# ZU1 SYSTEM BLOCK DIAGRAM

**PROJECT : ZU1**  
**Quanta Computer Inc.**

|   | <b>Block Diagram</b> | 3B  |
| Date: Tuesday, April 10, 2007 Sheet 1 of 39 |                      |     |

**LED Board**

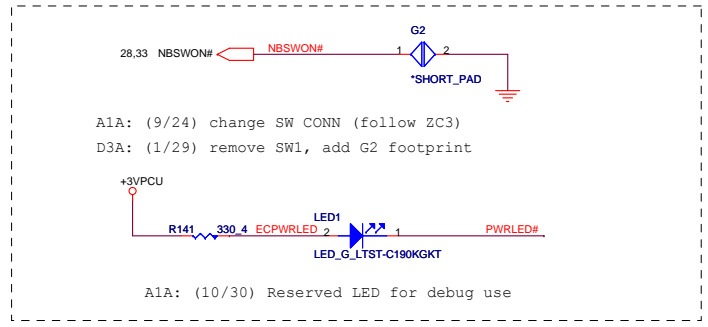
A1A: (9/27) Add LED Board CONN (10pin)  
 E3A: (3/30) change ESD protect Diode location from LED/B to MB (Add D3)  
 A1A: (10/26) Add SUSLED#

## EMI Cap

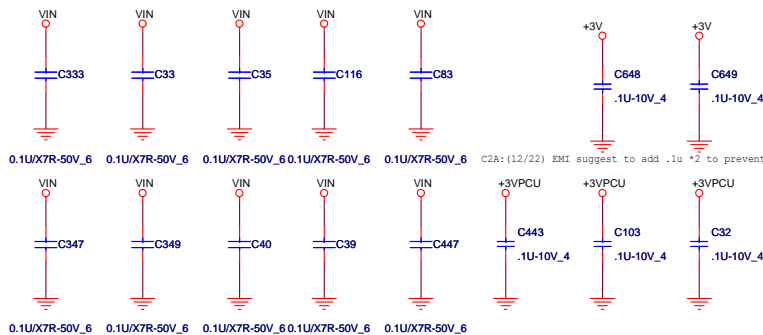
A1A: (10/19) EMI suggest : Add the VIN power shape bypass cap 0.1uF x 10pcs  
Add the +3VPCU power traces bypass cap 0.1uF x 3pcs

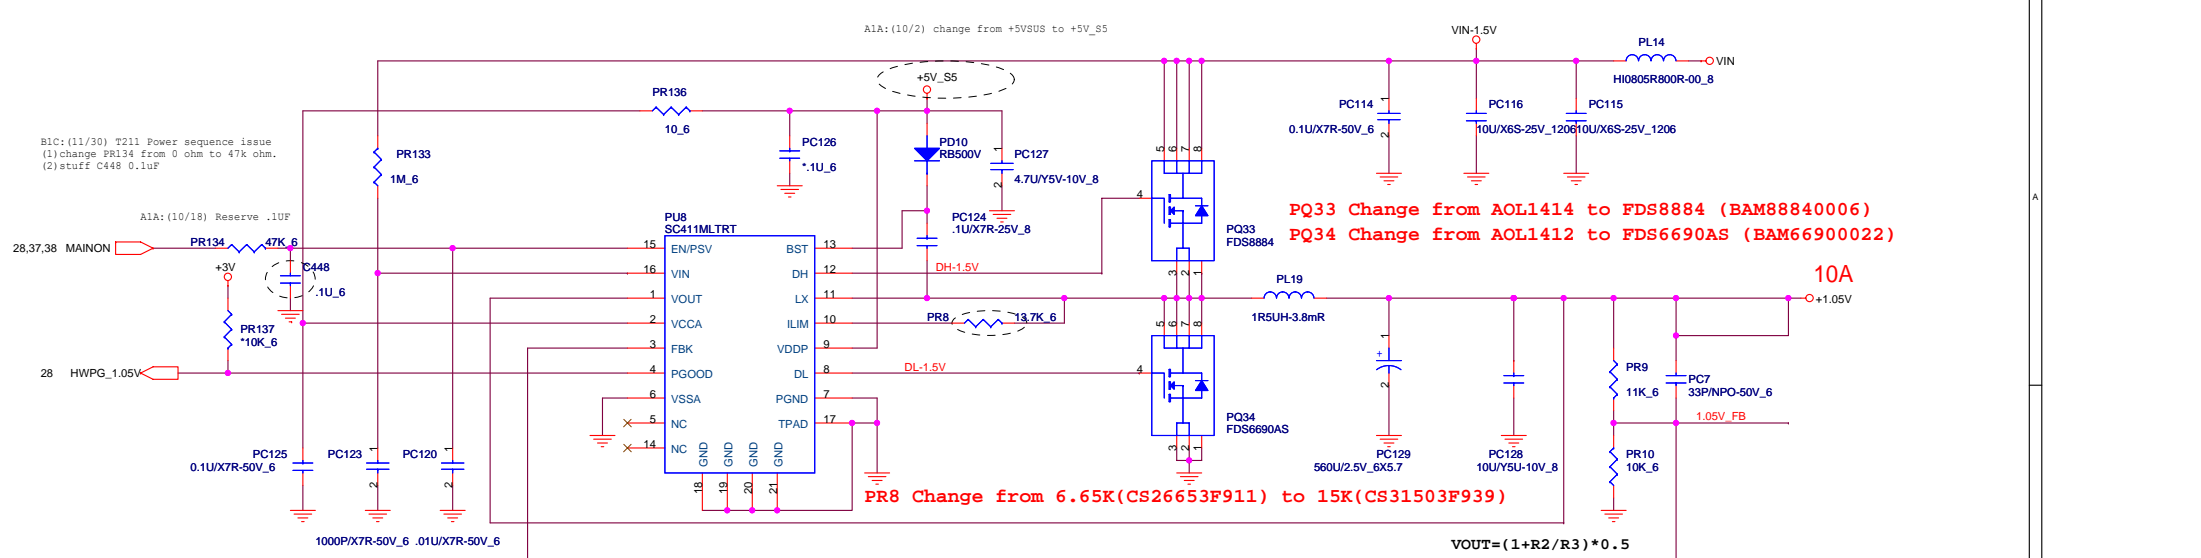
B1C: (11/30) T211 Power sequence issue  
 (1) change PR134 from 0 ohm to 47k ohm.  
 (2) stuff C448 0.1uF

**PQ33 Change from AOL1414 to FDS8884 (BAM88840006)**  
**PQ34 Change from AOL1412 to FDS6690AS (BAM66900022)**

**PR8 Change from 6.65K(CS26653F911) to 15K(CS31503F939)**

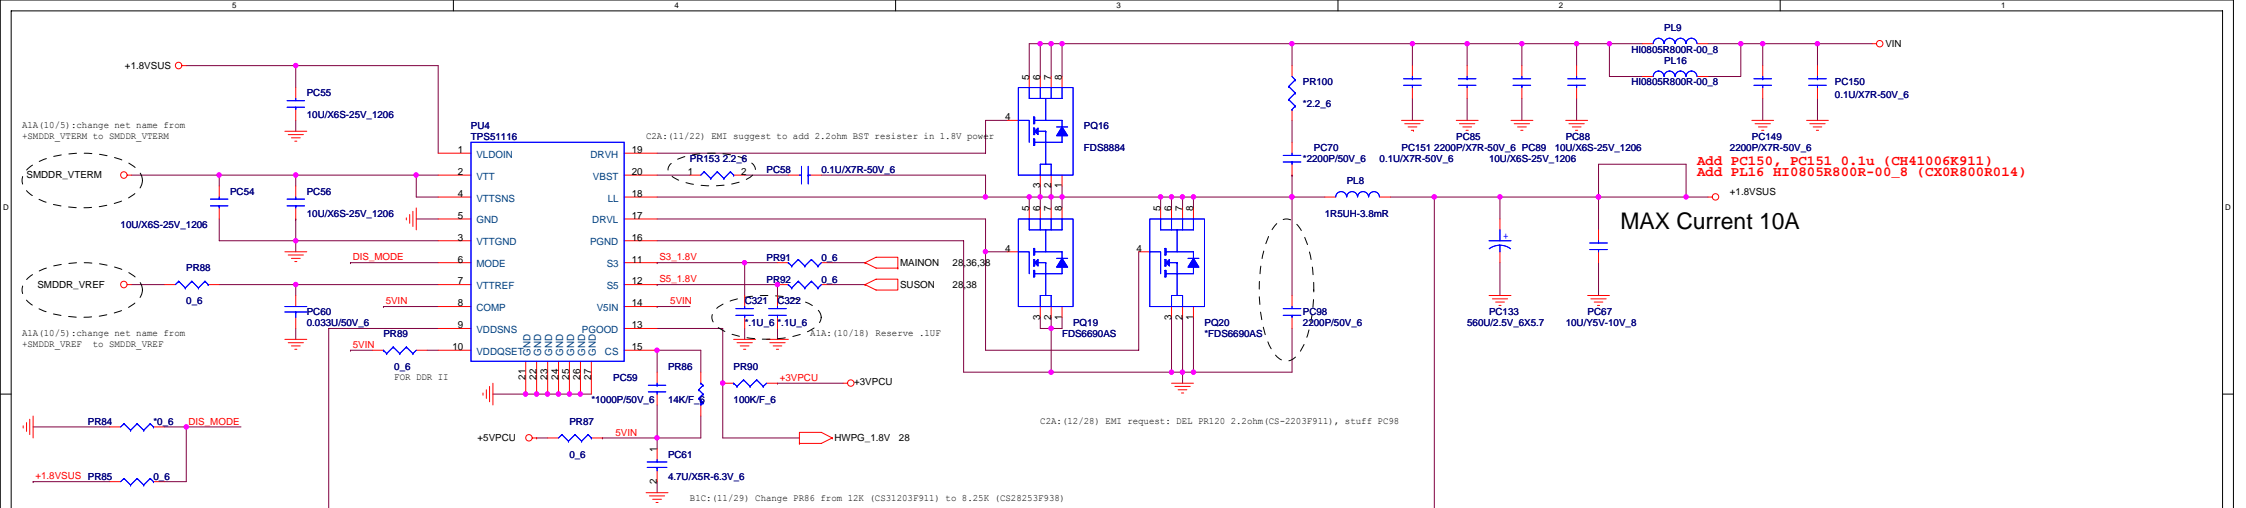
**PR9 Change from 20K to 11K (CS31103F926)**

B1C: (11/29) Change PR8 from 20K(CS32003F933) to 6.65K ohm (CS26653F911)

|       | <b>Charger (ISL6251)</b> | 3B             |

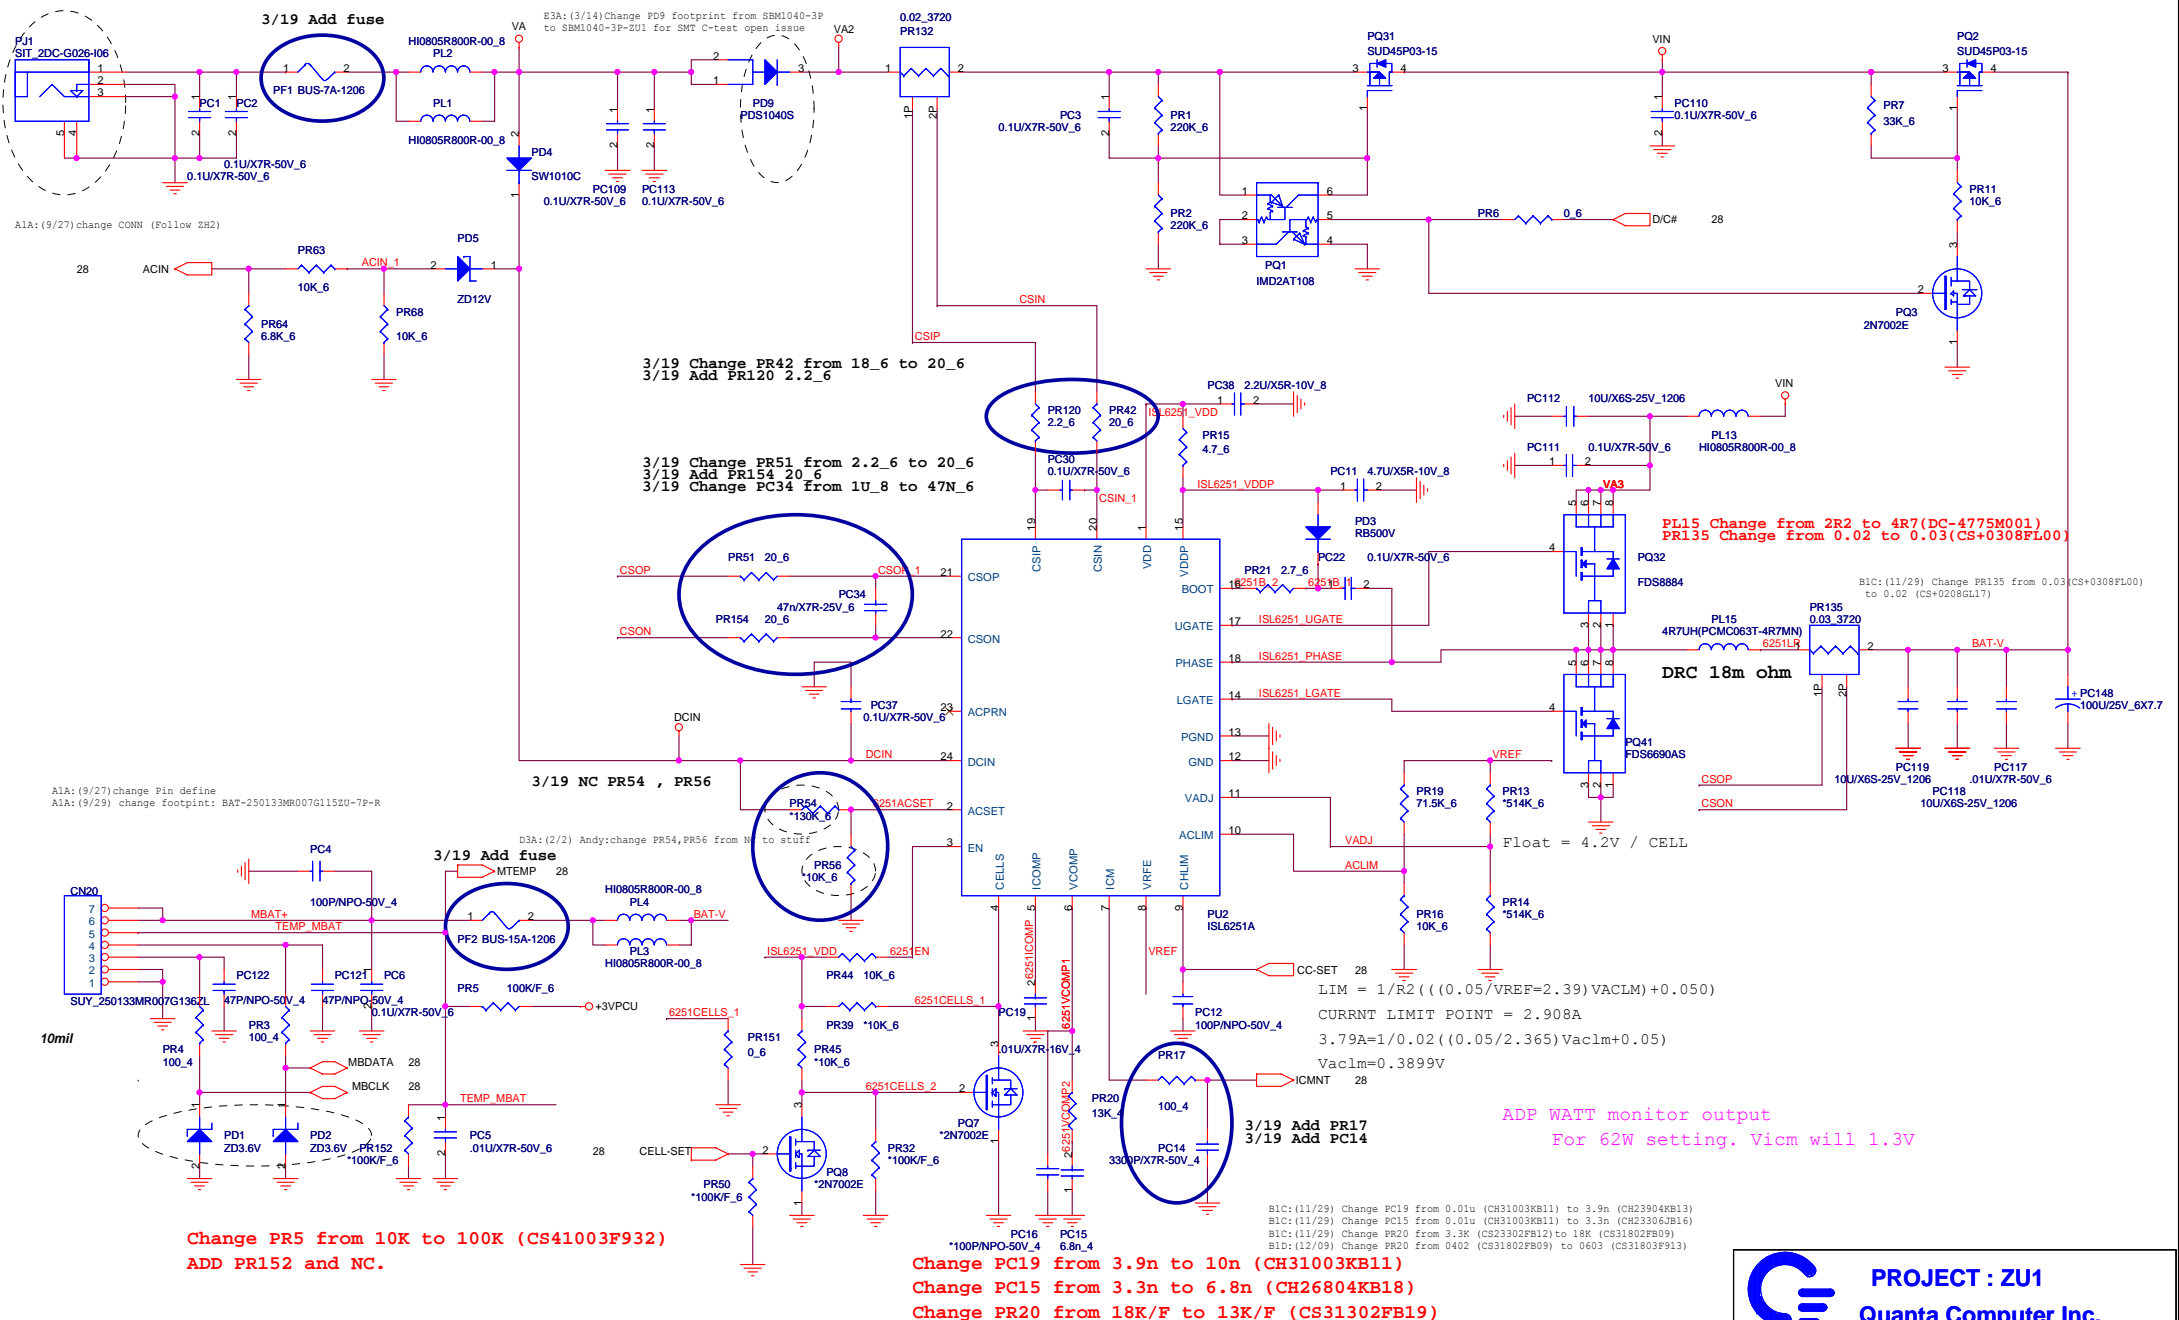
3/19 Change PR42 from 18\_6 to 20\_6  
3/19 Add PR120 2.2\_6

3/19 Change PR51 from 2.2\_6 to 20\_6  
3/19 Add PR154 20\_6  
3/19 Change PC34 from 1U\_8 to 47N\_6

PL15 Change from 2R2 to 4R7(DC-4775M001)  
PR135 Change from 0.02 to 0.03(CS+0308FL00)

B1C: (11/29) Change PR135 from 0.03 (CS+0308FL00) to 0.02 (CS+0208GL17)

Change PR5 from 10K to 100K (CS41003F932)  
ADD PR152 and NC.

Change PC19 from 3.9n to 10n (CH31003KB11)  
Change PC15 from 3.3n to 6.8n (CH26804KB18)  
Change PR20 from 18K/F to 13K/F (CS31302FB19)

B1C: (11/29) Change PC19 from 0.01u (CH31003KB11) to 3.9n (CH23904KB13)  
B1C: (11/29) Change PC15 from 0.01u (CH31003KB11) to 3.3n (CH23306B16)  
B1C: (11/29) Change PR20 from 3.3K (CS23302FB12) to 18K (CS31802FB09)  
B1D: (12/09) Change PR20 from 0402 (CS31802FB09) to 0603 (CS31803FB13)
